MEMORANDUM

UTAH DEPARTMENT OF TRANSPORTATION

SUBJECT: Standards Committee Meeting Minutes and Next Meeting

STD. DWG. NO.
AT 15

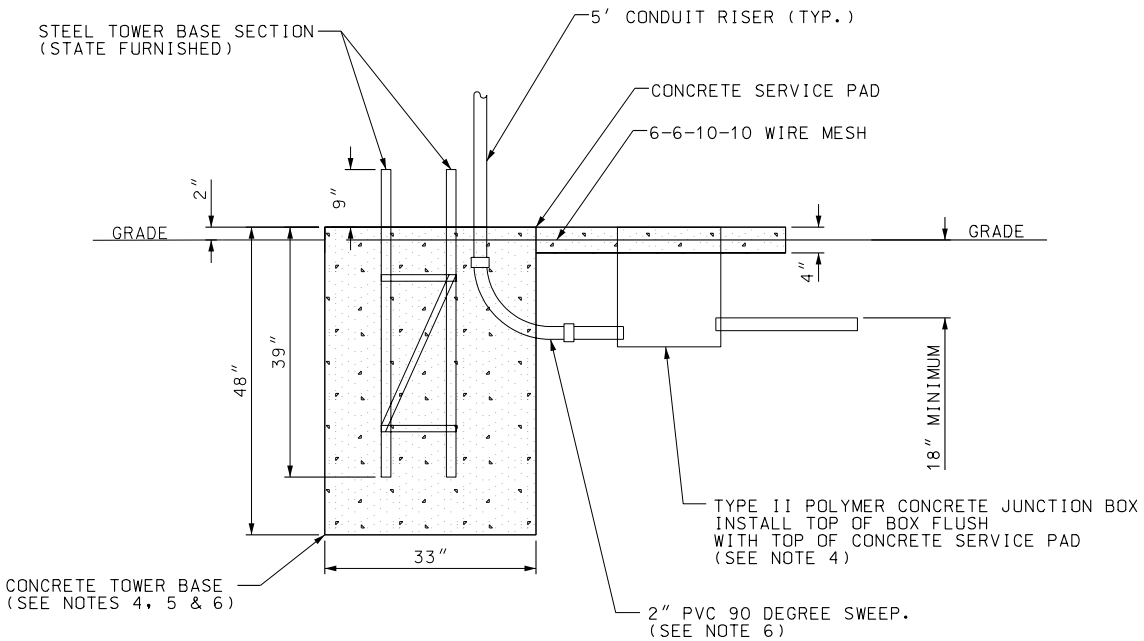
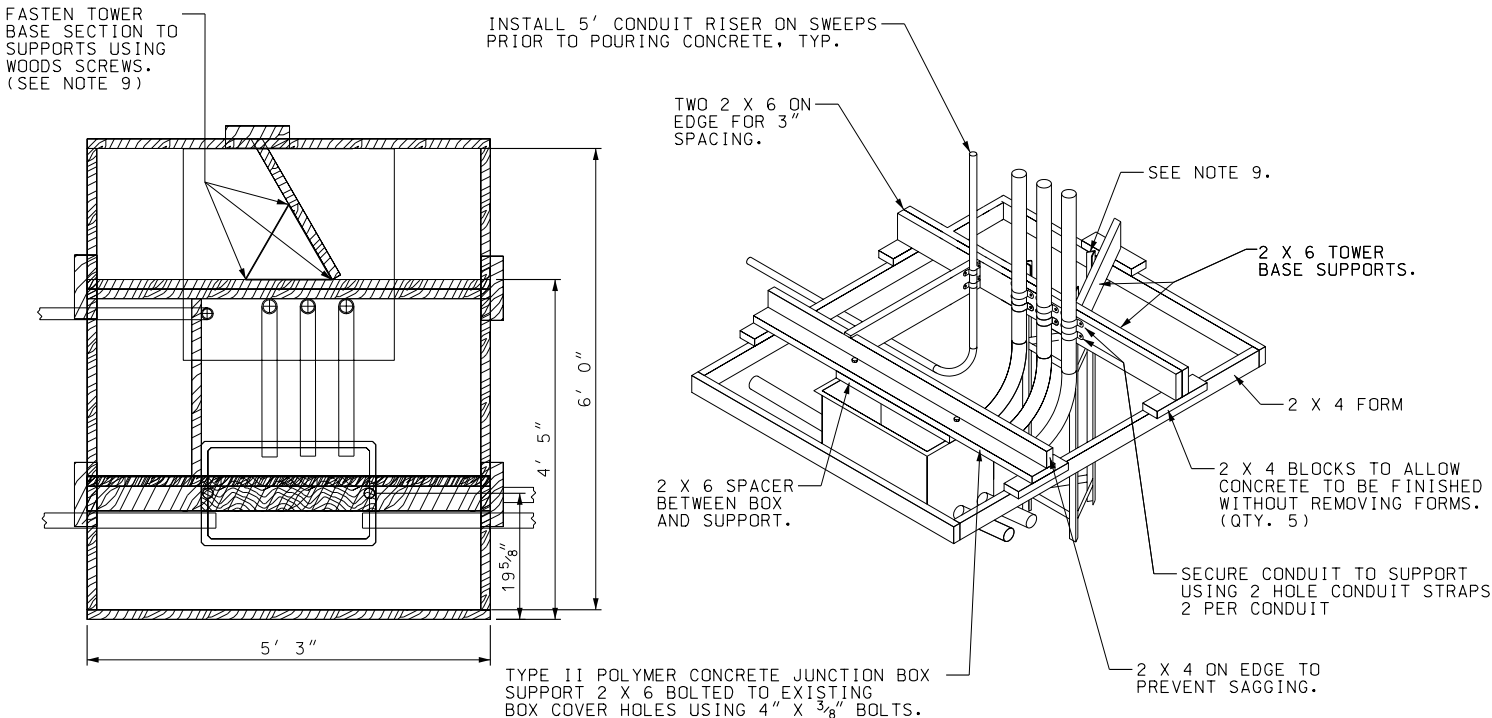
- Referring to drawing AT 15, Jason asked about the statement “Engineer to verify that tower will be accessible for service when bent over.” What does this mean? Sam said the fence is so close that when the tower is folded down it extends over the fence and can’t be worked on. He said they have had to come back in to correct the problem.

Revised Standard Drawings AT15-17 and Specification 13592 to reflect more involvement by state forces to install the sensitive weather instrumentation and per recommendation from the August 28, 2003 Standard Committee Meeting.

The standard drawings have been adapted from the installation guides from the state contracted weather equipment provider. The drawings have been modified to include UDOT requirements for access, junction box details and fencing protection.

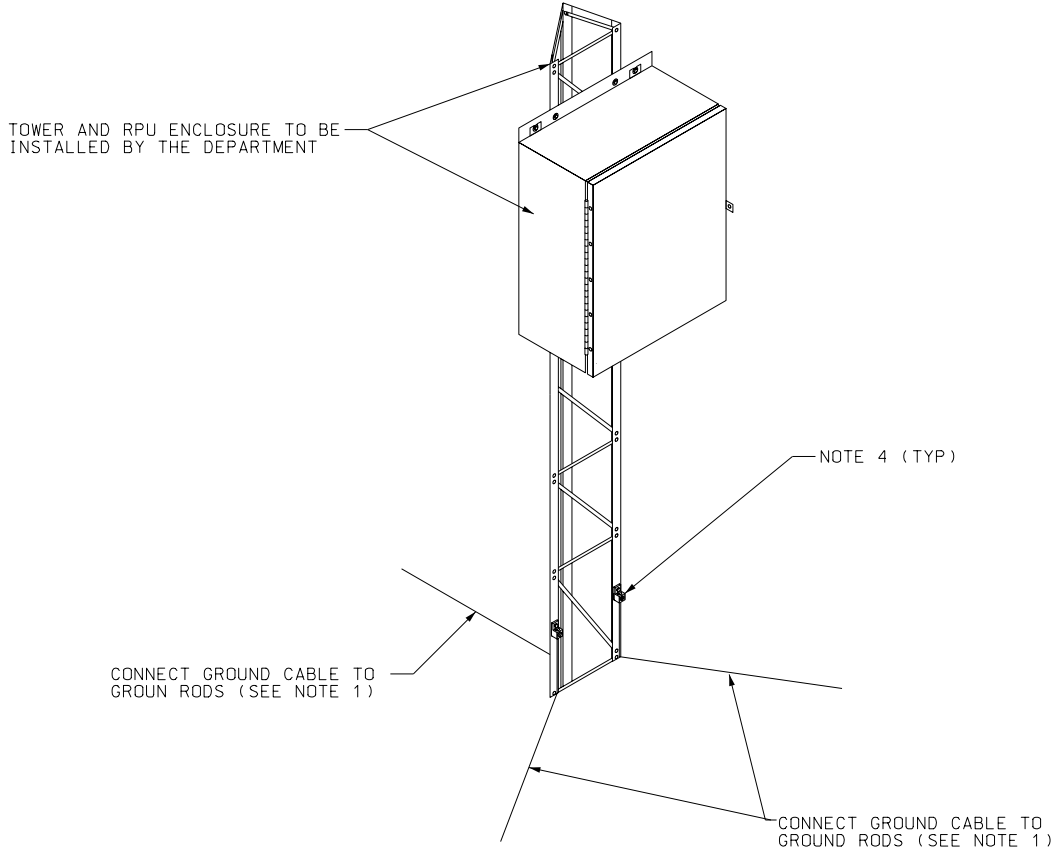
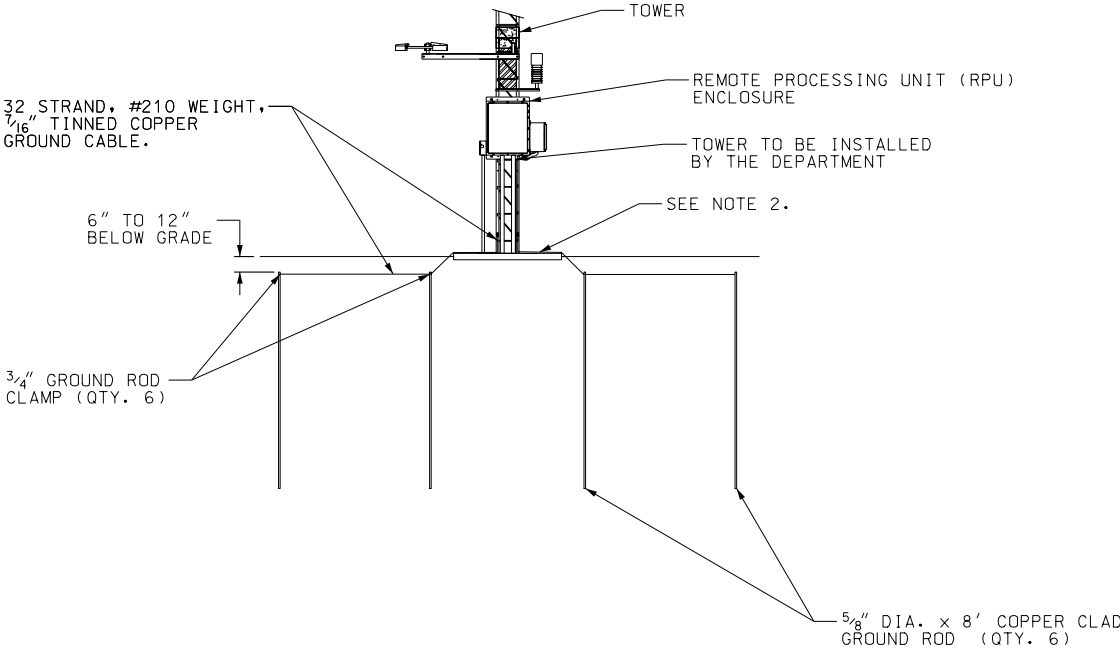
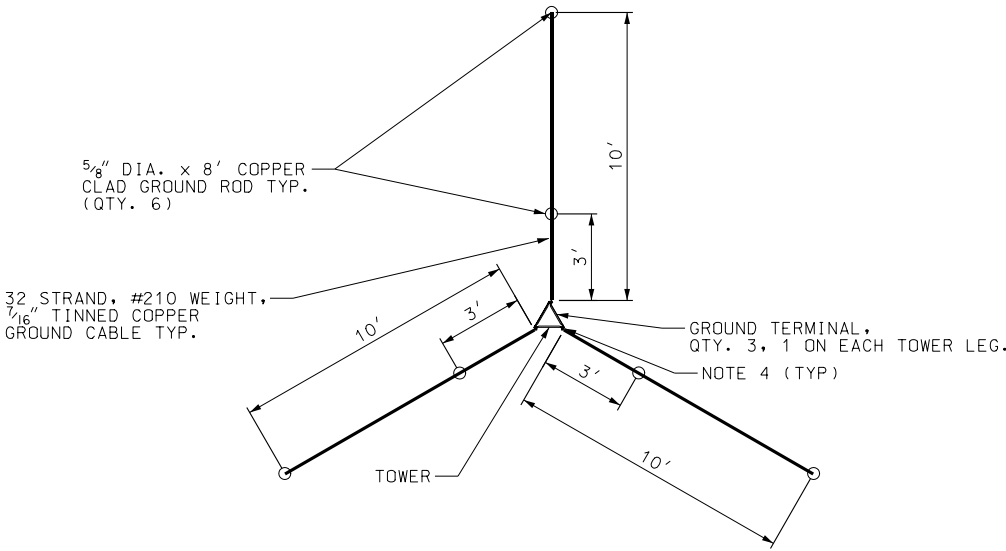
- On AT 17, Jason asked if the reference to “Acorn Ground Rod” was to a proprietary item. Sam said their construction crew informed him that this is a standard item. Sam commented about the 10-foot ground rod and that it is difficult to install. He said has requested approval to change it.
